ADDENDUM 01

DATE: July 24, 2014
TO: Continental 294 Fund LLC
FROM: Scott Tabary
Duplantis Design Group, PC
SUBJECT: Spring at Fremaux Town Center
Slidell, LA

MISCELLANEOUS CHANGES, ADDITIONS AND CORRECTIONS TO DRAWINGS:

DRAWN DGS
 CHECKED DEB
 ISSUED DATE 7/24/14
 ISSUED FOR PERMITTING
 PROJECT NO. 14-248
 FILE 14-248 C-6 UTILITY
 SHEET C-6.5

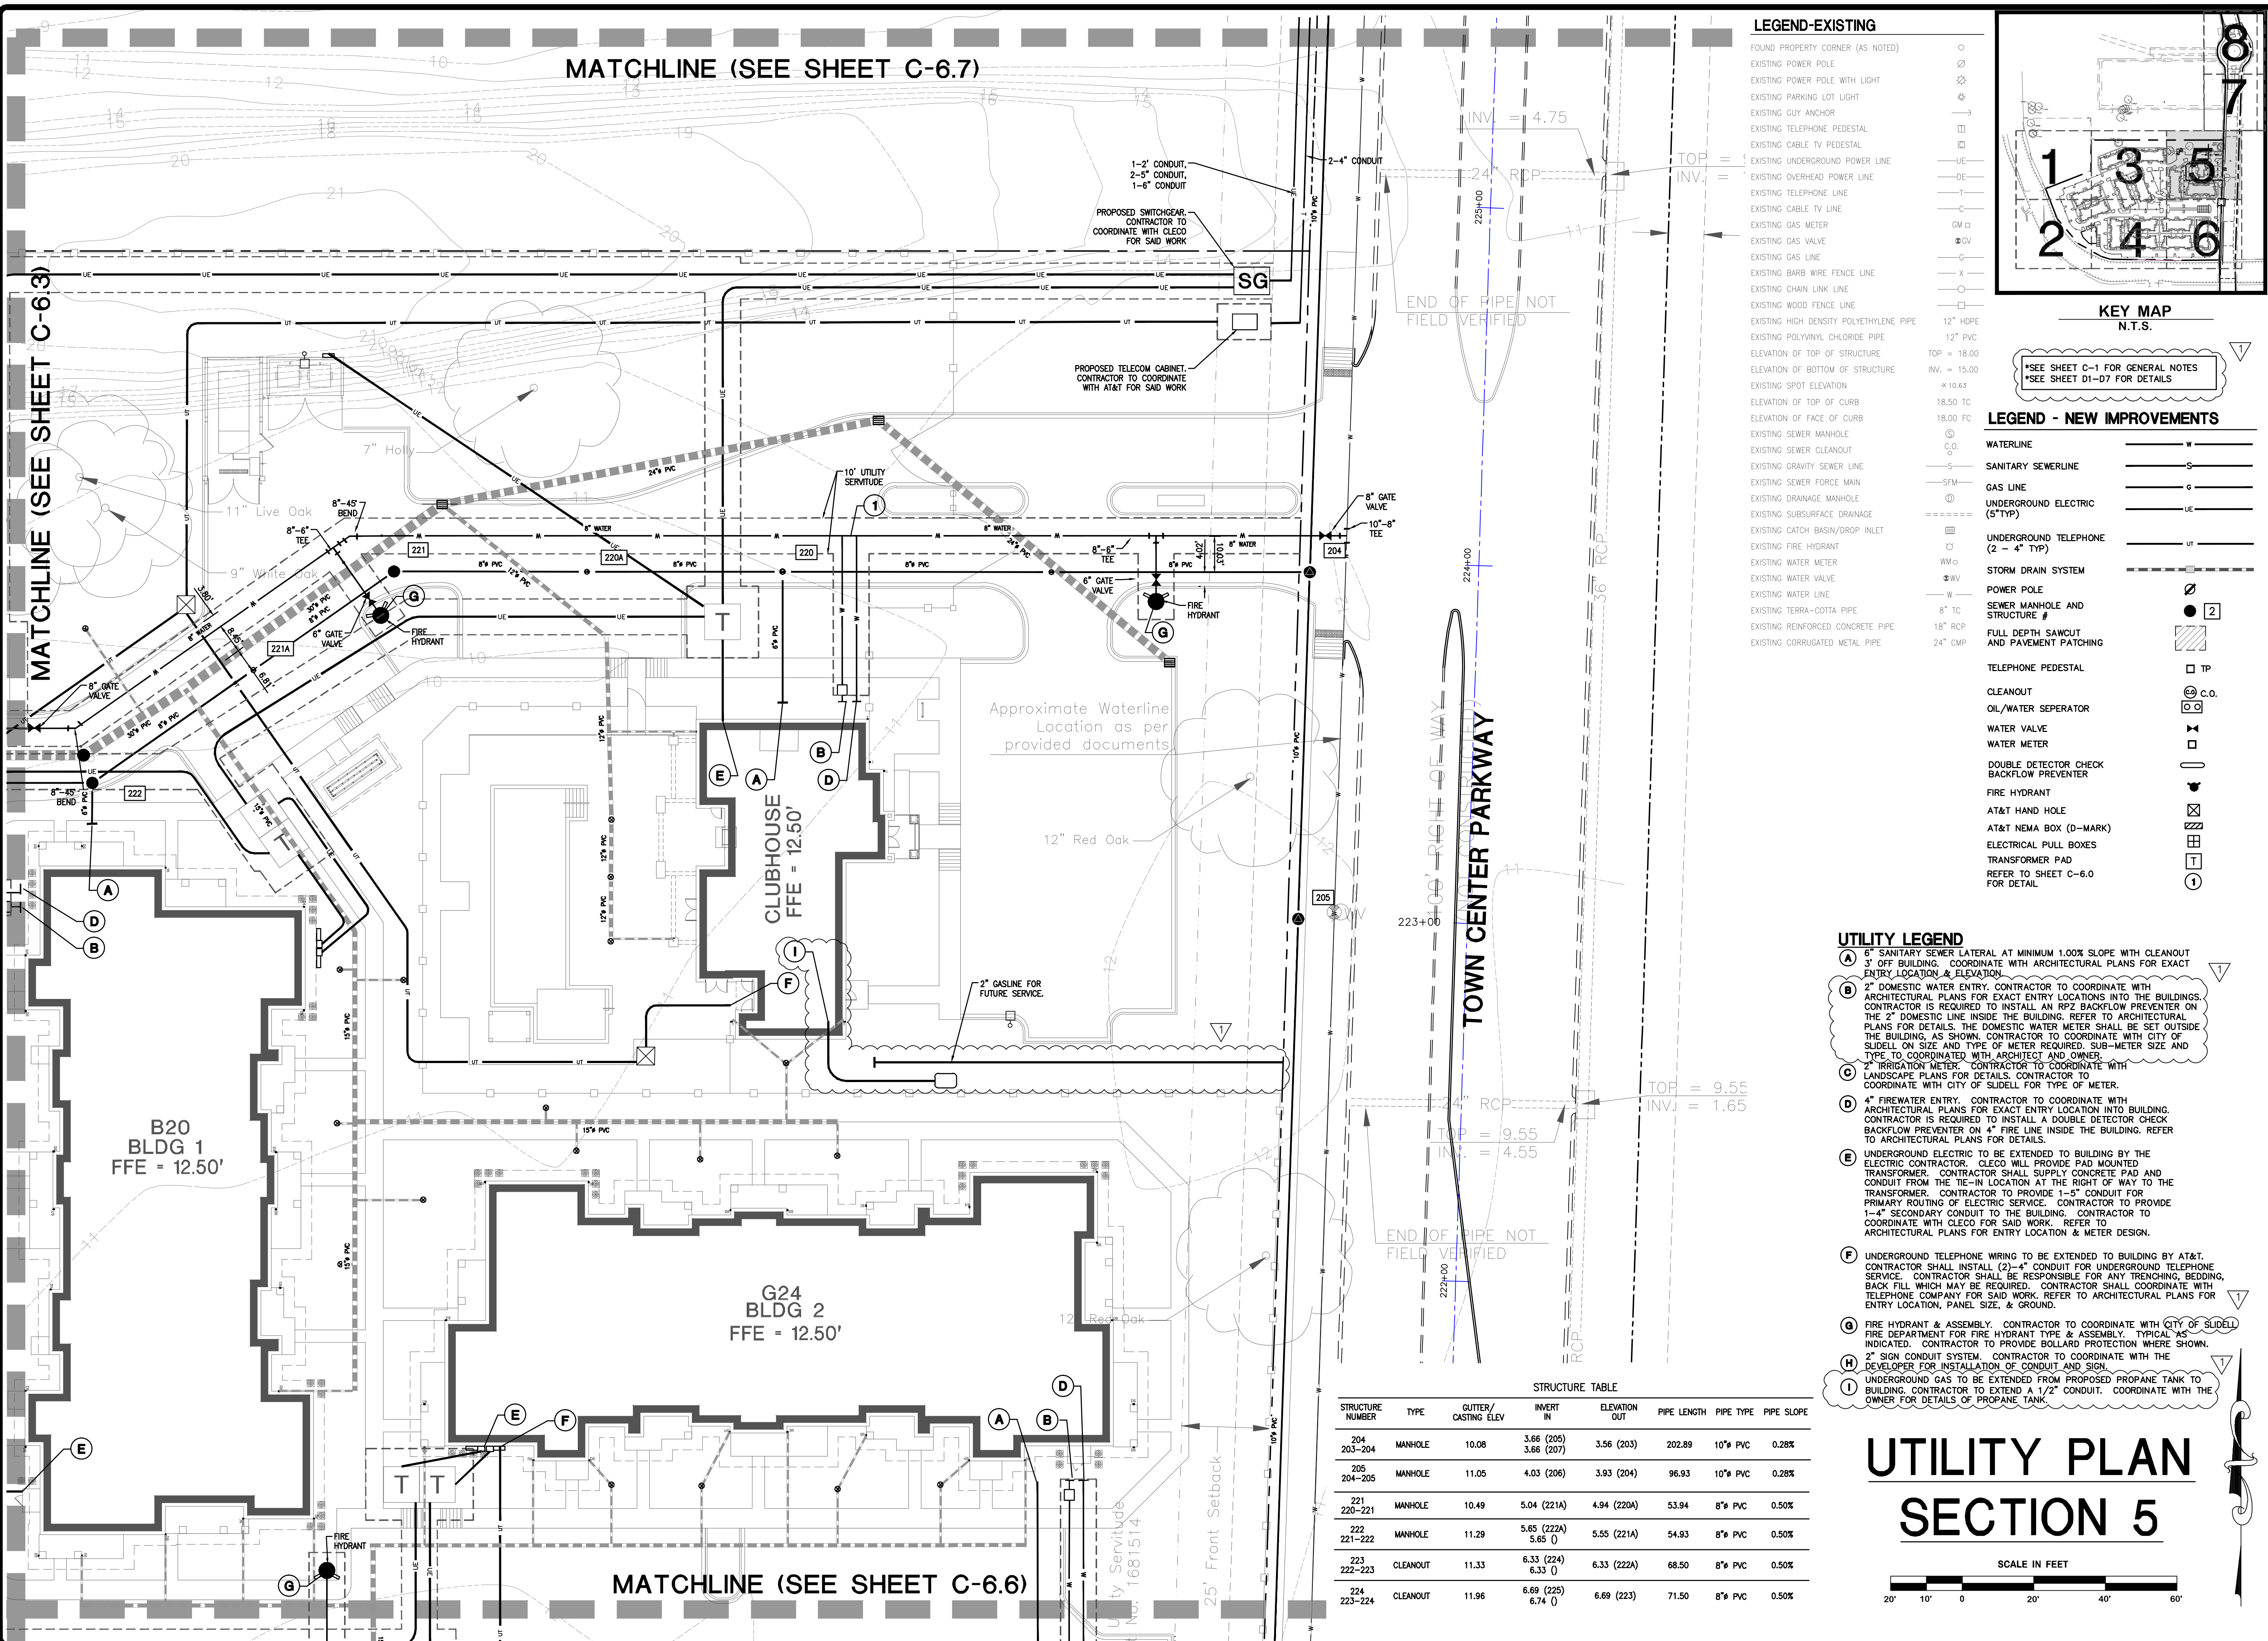
P. Sheet C-6.5

1. Added propane tank location and gas line to building outside of the southeast corner of the clubhouse.

DRAWN
DGS
CHECKED
DEB
ISSUED DATE
7/24/14
ISSUED FOR
PERMITTING
PROJECT NO.
14-248
FILE
14-248 C-8 PH2 EROSION
SHEET
C-8.1

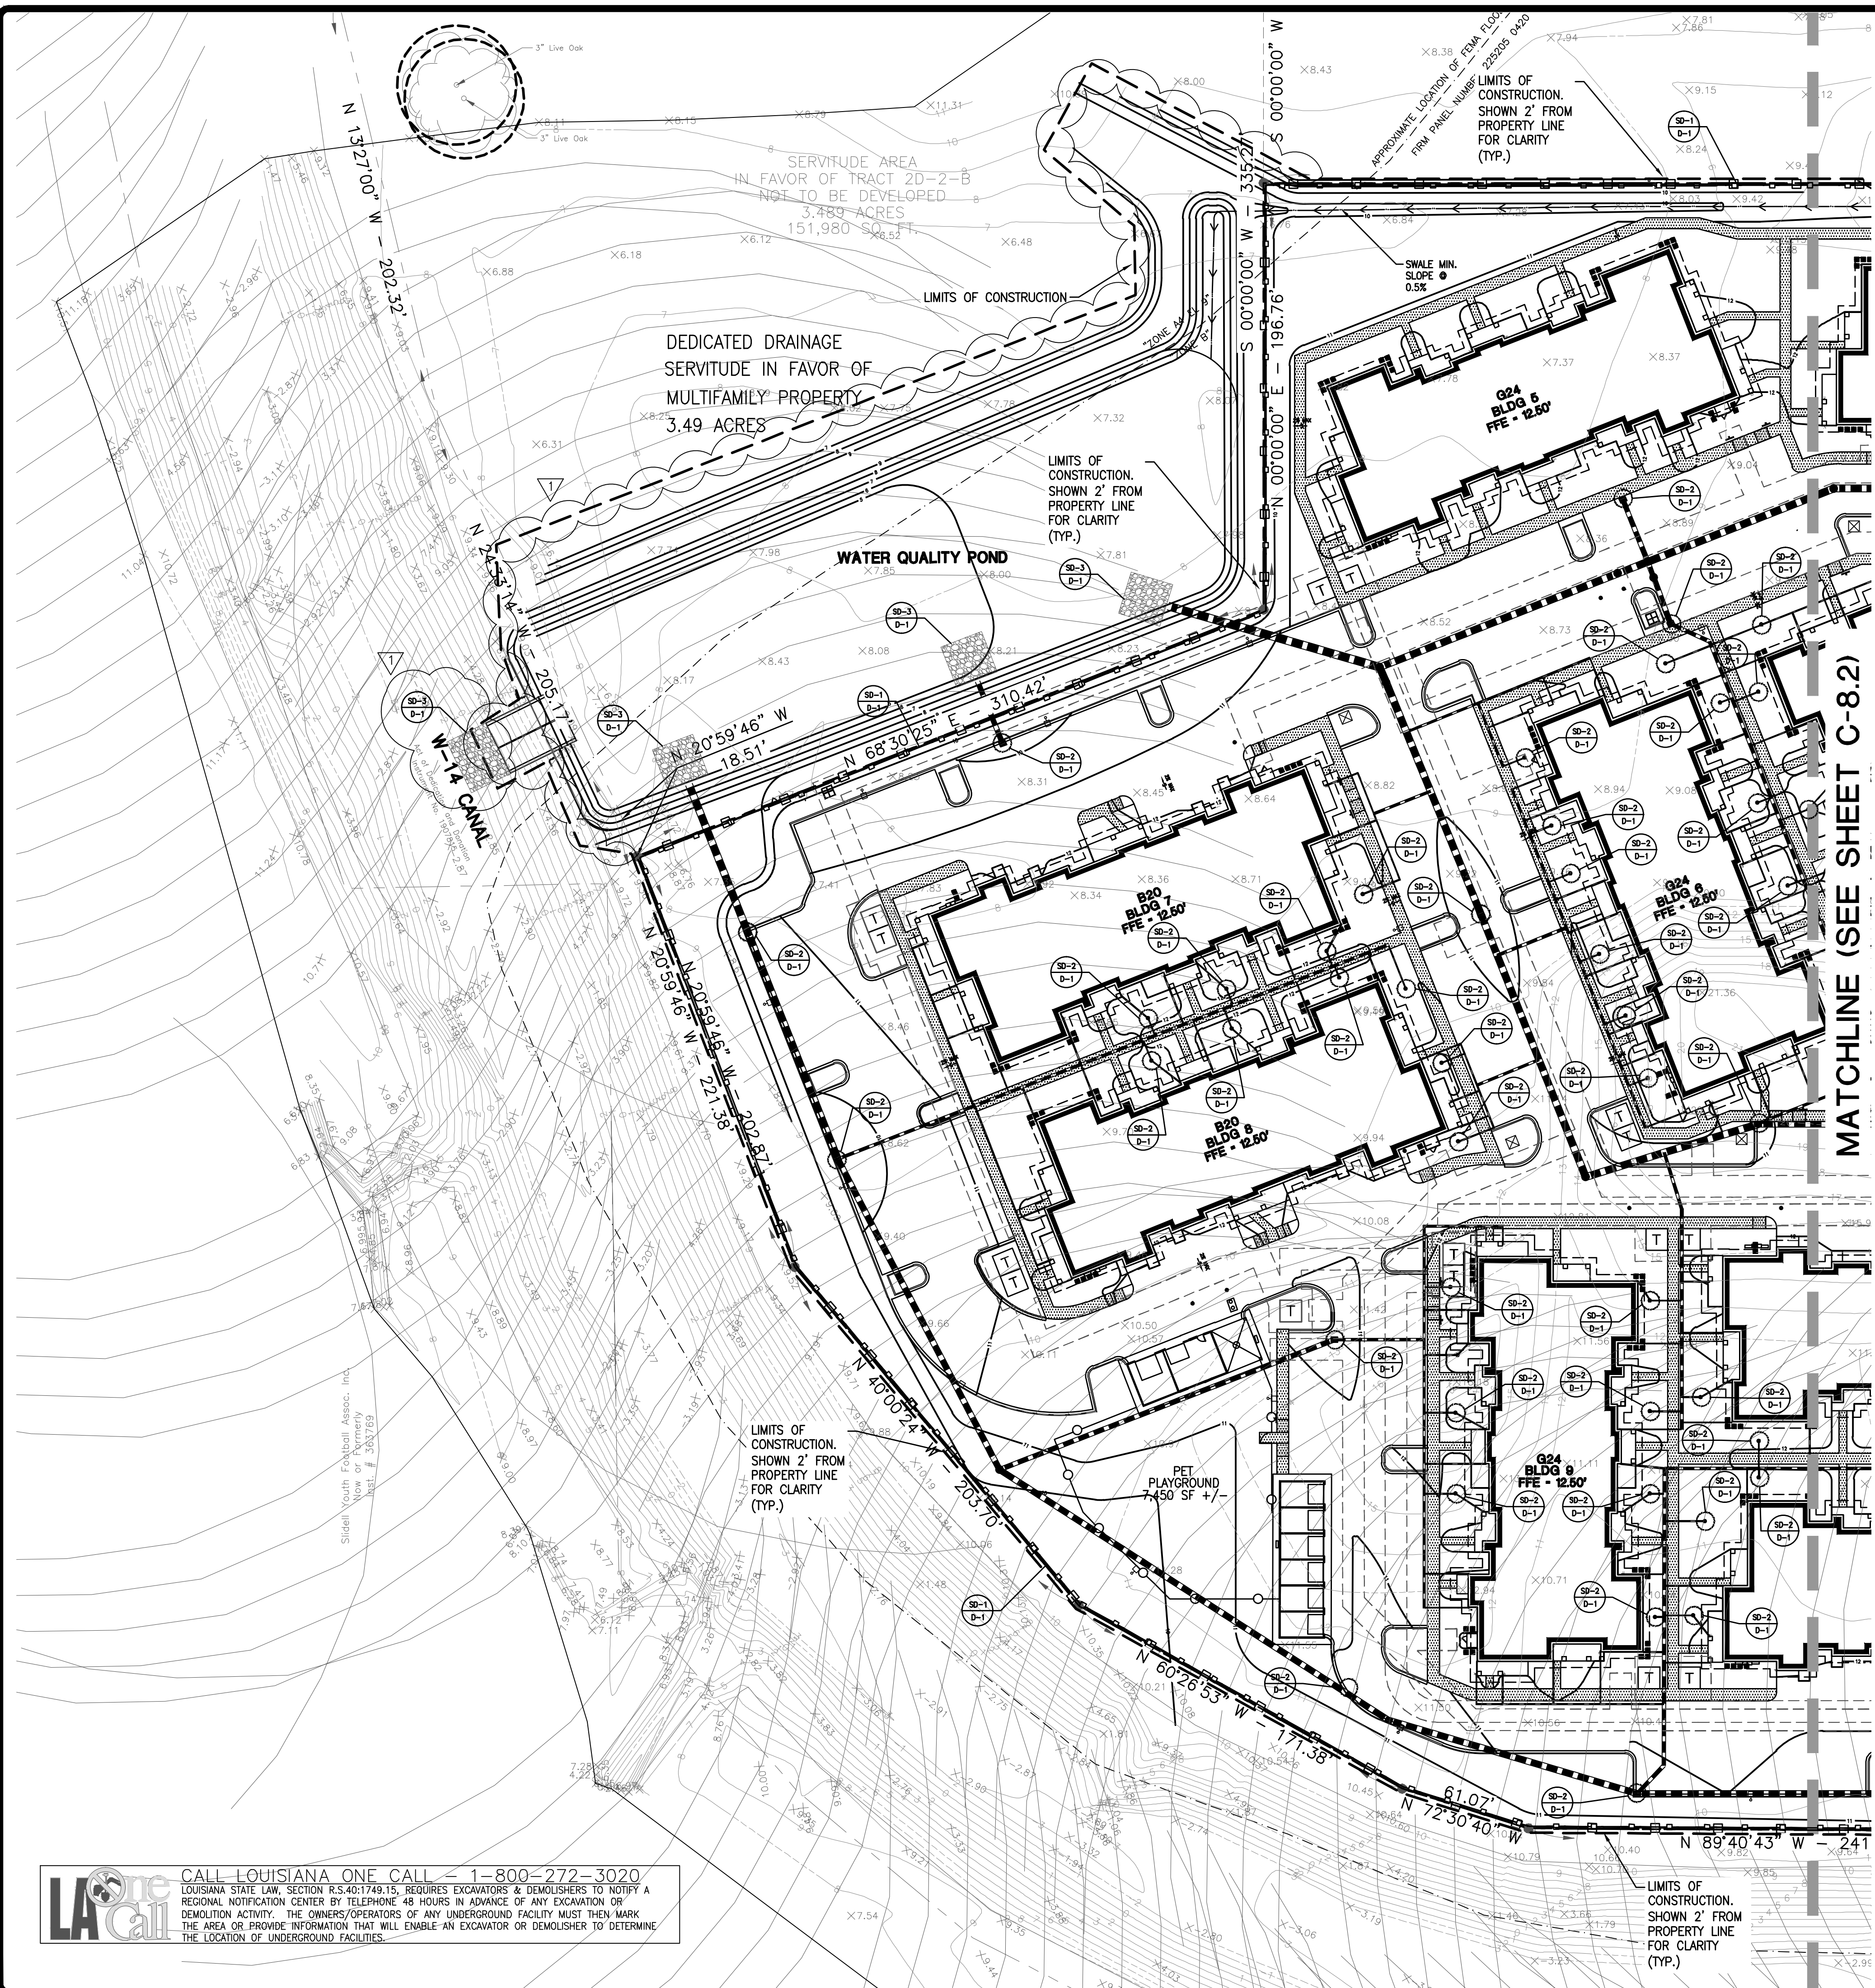
R. Sheet C-8.1

1. Adjusted Limits of construction to encompass the pond area.
2. Added rip rap to Weir outfall from the pond

DRAWN DGS
CHECKED DEB
ISSUED DATE 7/24/14
ISSUED FOR PERMITTING
PROJECT NO. 14-248
FILE 14-248 C-8 PH2 EROSION
SHEET C-8.2

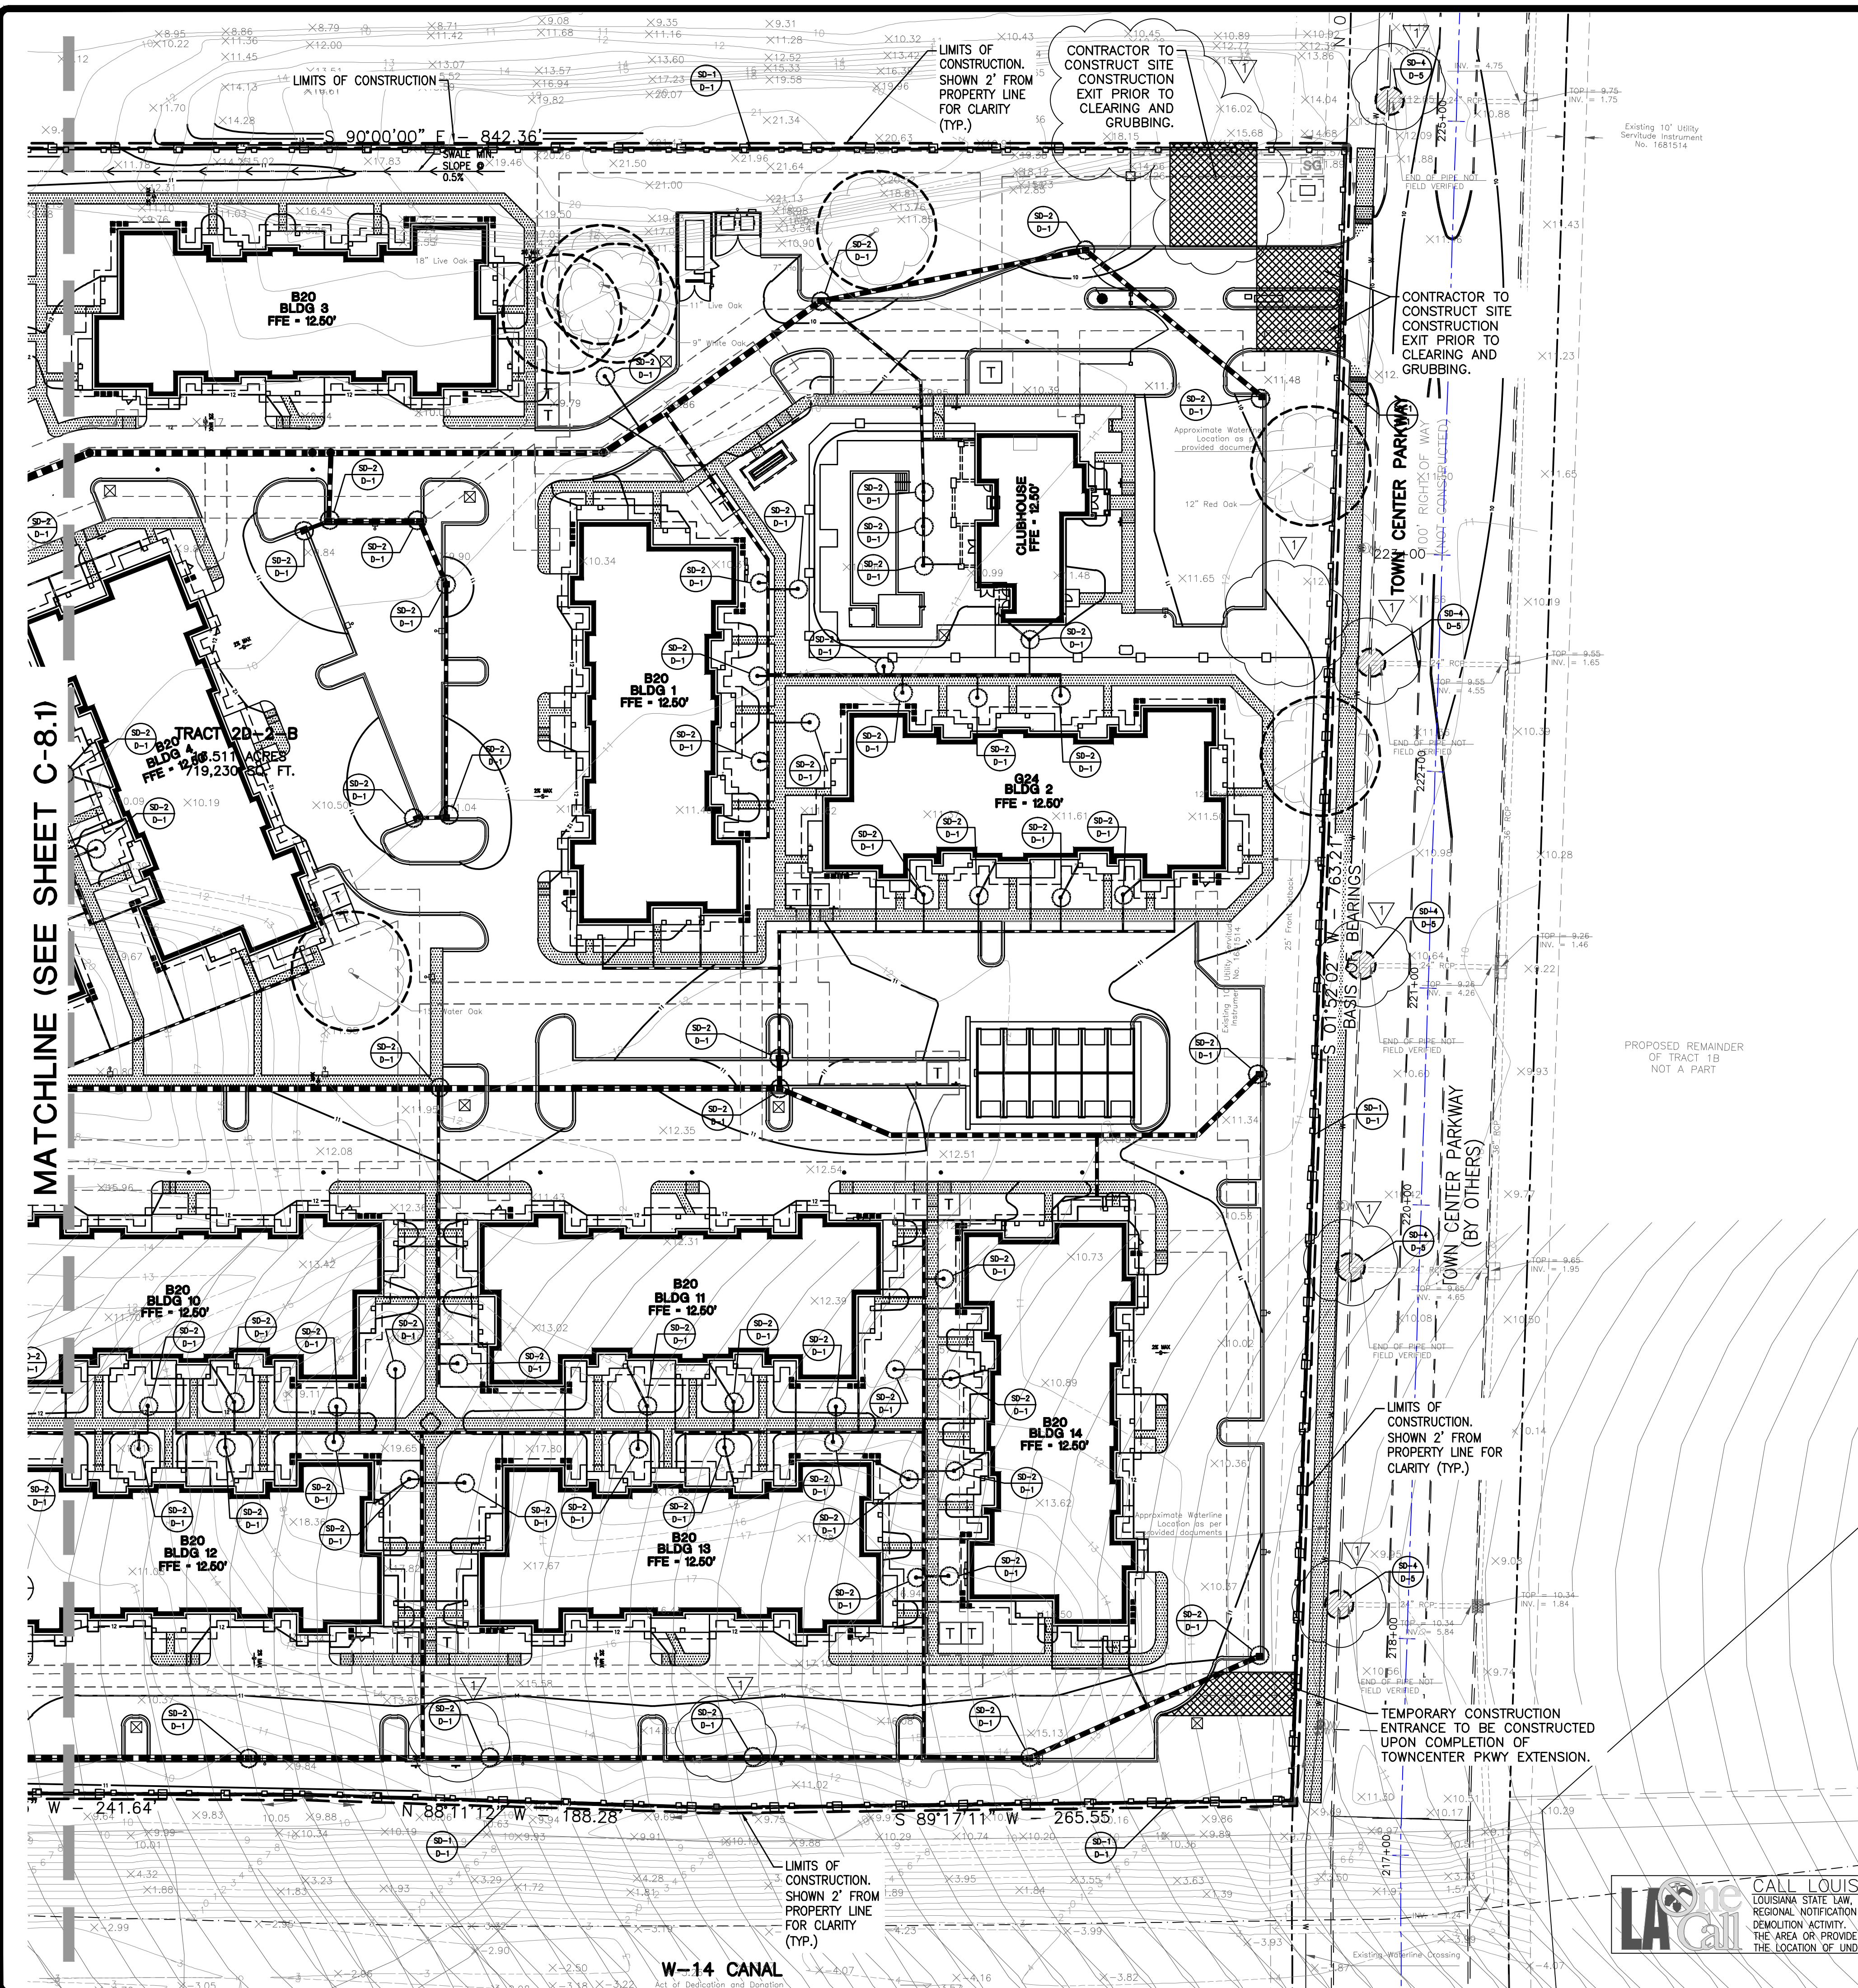
S. Sheet C-8.2

1. Shifted Erosion control along Town Center Parkway to west side of Roadway.
2. Added construction exit for temporary road area along north property line.
3. Removed tree protection from tree at southeast corner of clubhouse parking area, as the tree is being removed.
4. Added 2 inlet protections along southern most curb and gutter in parking lot.
